Los Angeles to Pasadena Metro Blue Line Construction Authority
Los Angeles to Pasadena Metro Blue Line Light Rail Project

Value Engineering Study Report

Preliminary Basis for Design/Build Design

December 22, 1999

SHEET NO. CA-1
2 of 6

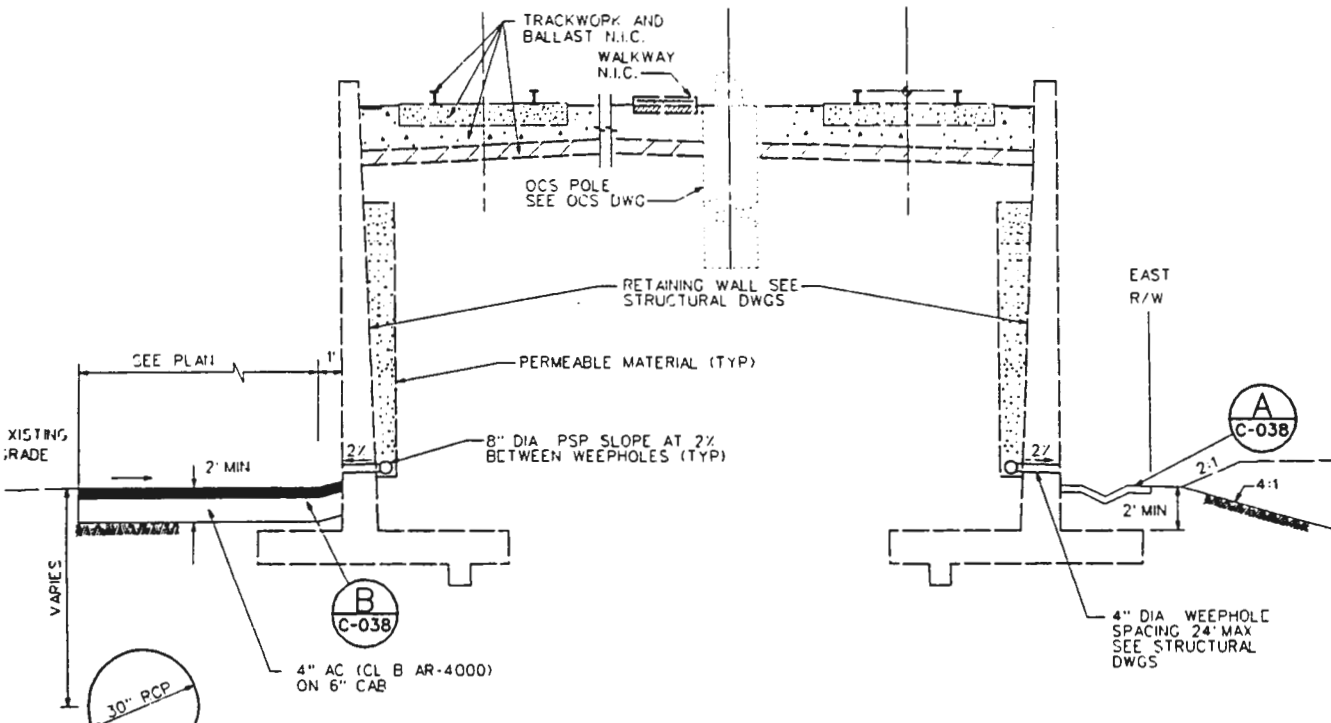
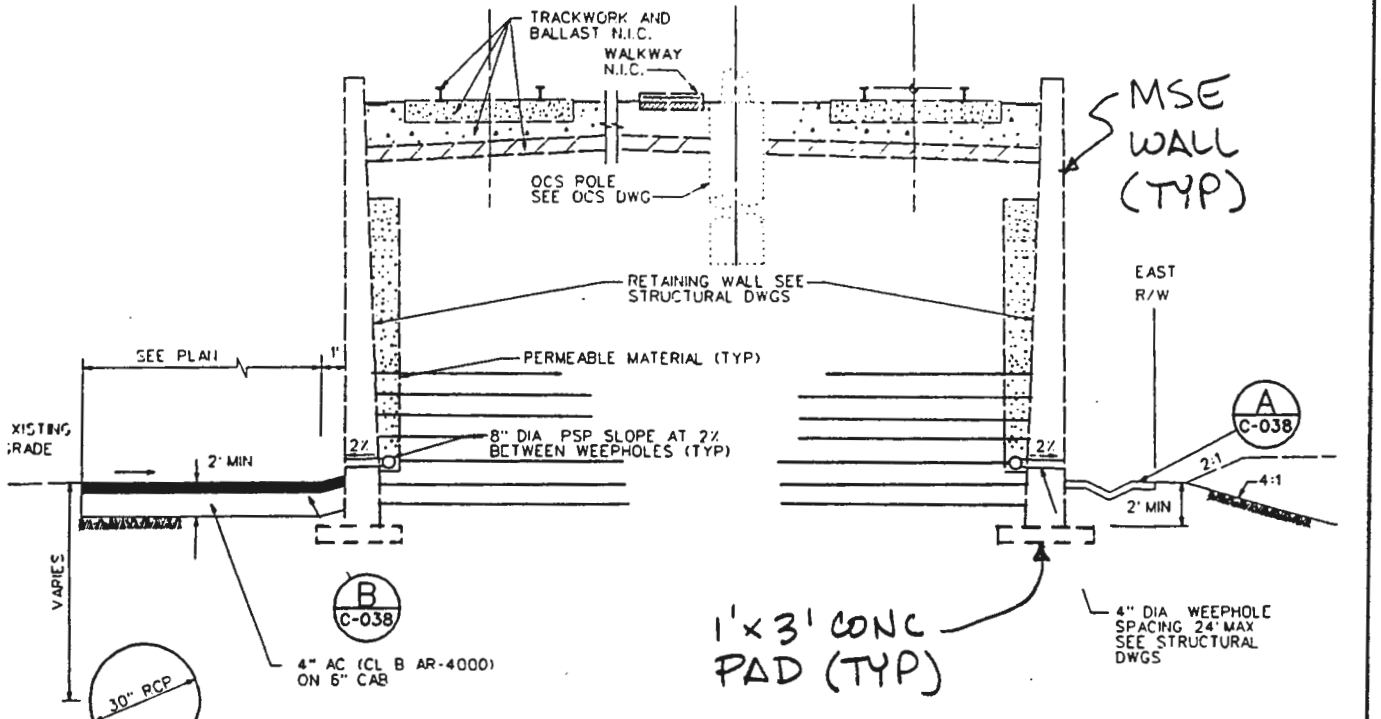
Several alternatives provide options for the concrete retaining walls along the alignment. Alt. Nos. CA-1, ASDM-2, ASDM-3, ASDM-4, and Y&S-4 suggest using mechanically stabilized earth walls, highway type concrete median barriers, crib walls or soil nailing to reduce the cost of these walls, as well as the time to construct them.

PROJECT:	PASADENA BLUE LINE LIGHT RAIL PROJECT	ALTERNATIVE NO.	CA-1
DESCRIPTION: FOR	SUBSTITUTE MACHANICALLY STABLIZED EARTH WALLS CAST-IN-PLACE CONCRETE RETAINING WALLS	SHEET NO.	1 of 6

CONTRACT NO	C6420
DRAWING NO	C-0600
SCALE	1"=40'
SHEET NO	148

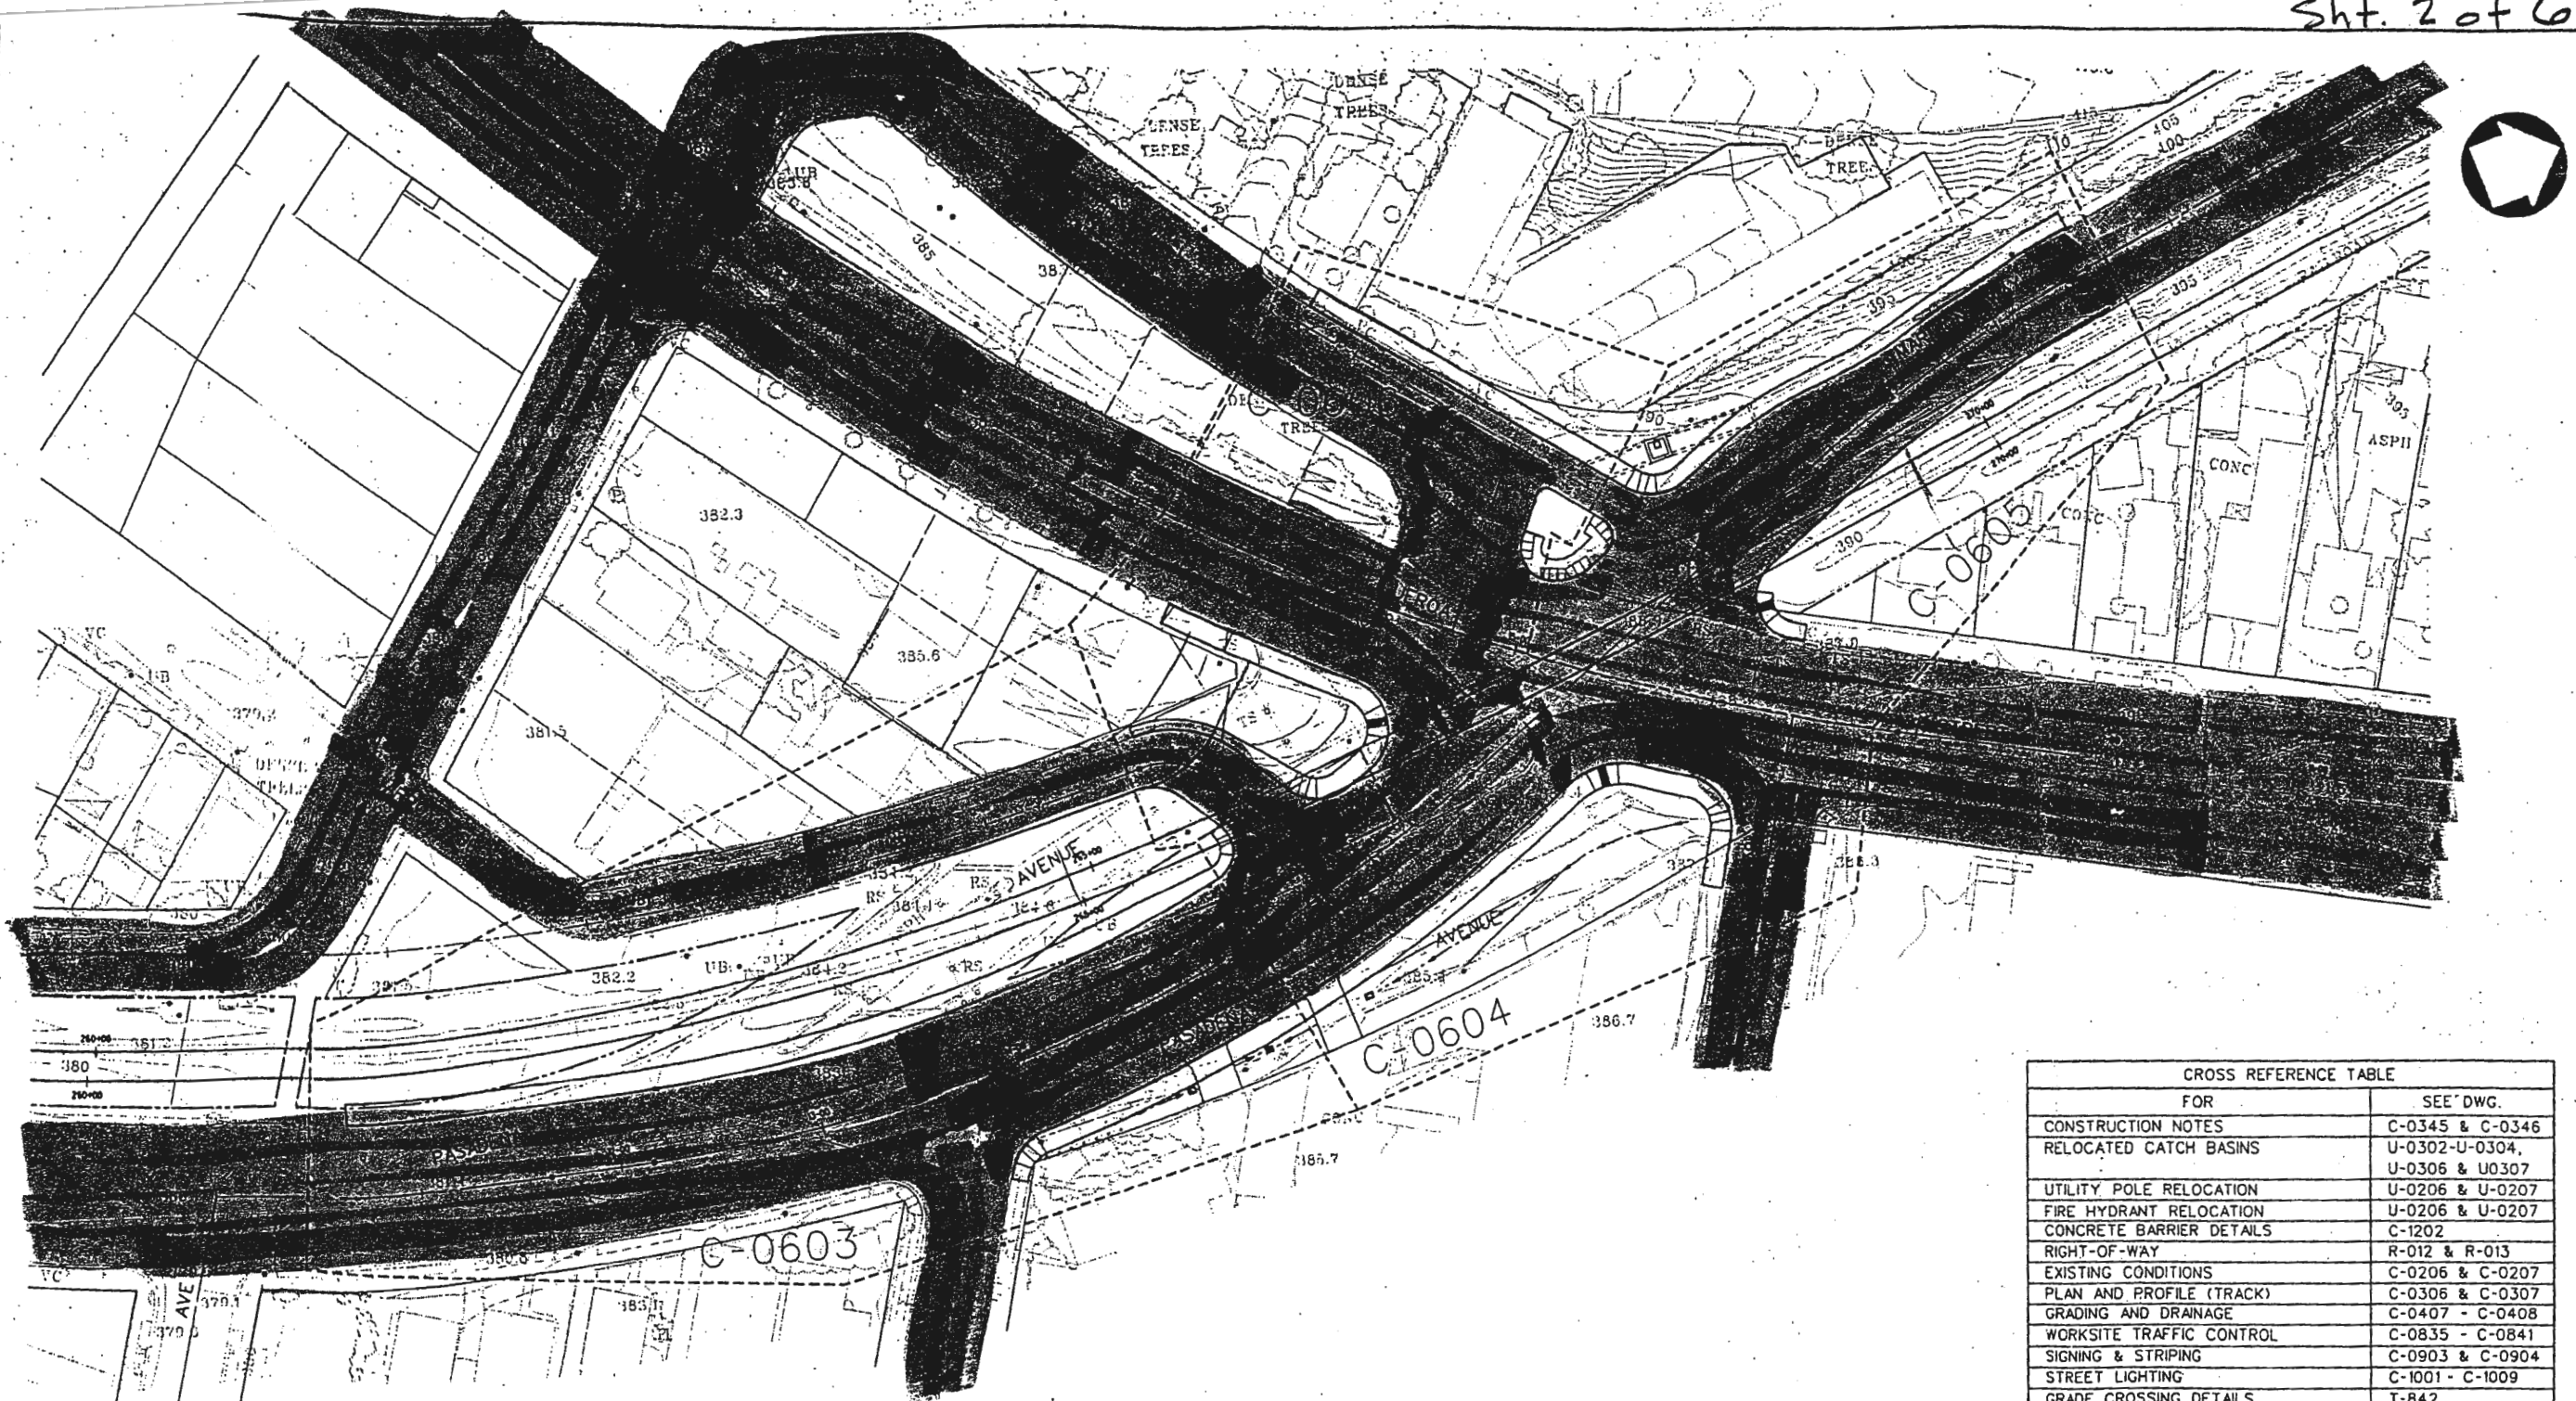
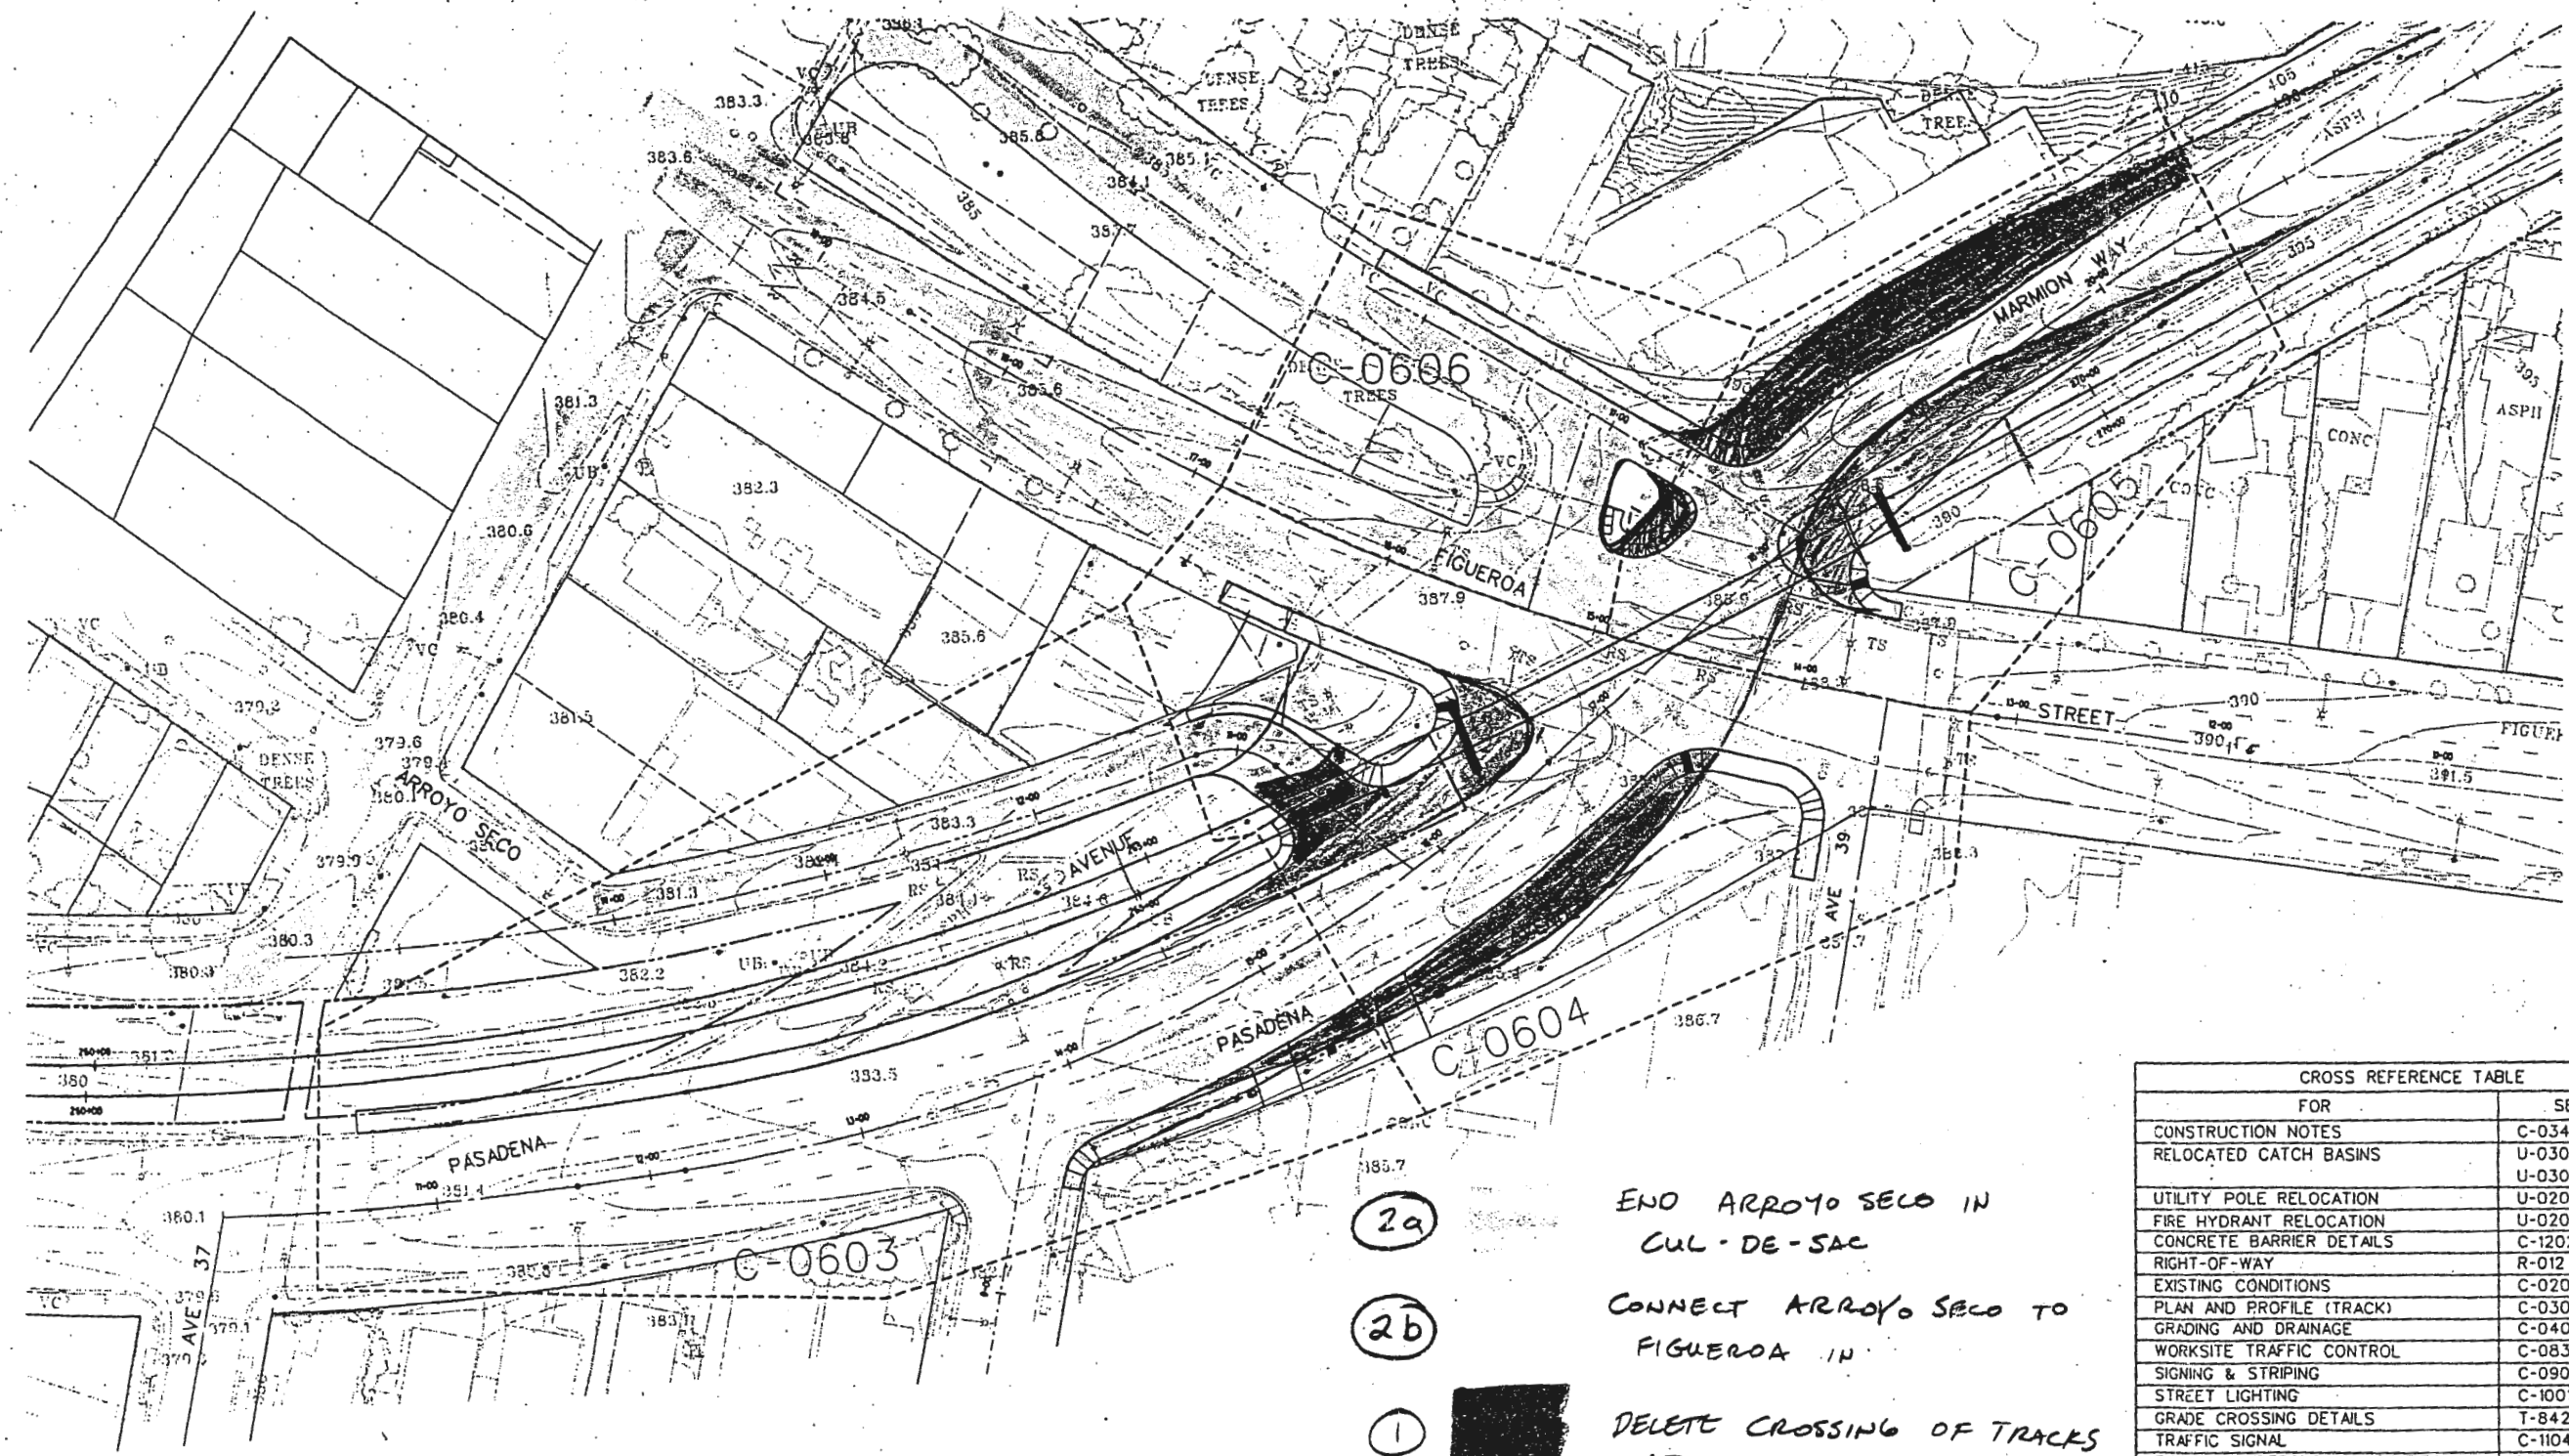
PROJECT:	PASADENA BLUE LINE LIGHT RAIL PROJECT	ALTERNATIVE NO.	LAR-2 LAR-3
DESCRIPTION:	REALIGN INTERSECTION AT FIGUEROA, PASADENA AVENUE AND ARROYO SECO AND SHORTEN GRADE SEPARATION BOX STRUCTURE	SHEET NO.	1 of 6

- 2a
 - 2b
 - 1
- END ARROYO SECO IN CUL-DE-SAC
- CONNECT ARROYO SECO TO FIGUEROA IN
- DELETE CROSSING OF TRACKS AT ARROYO SECO
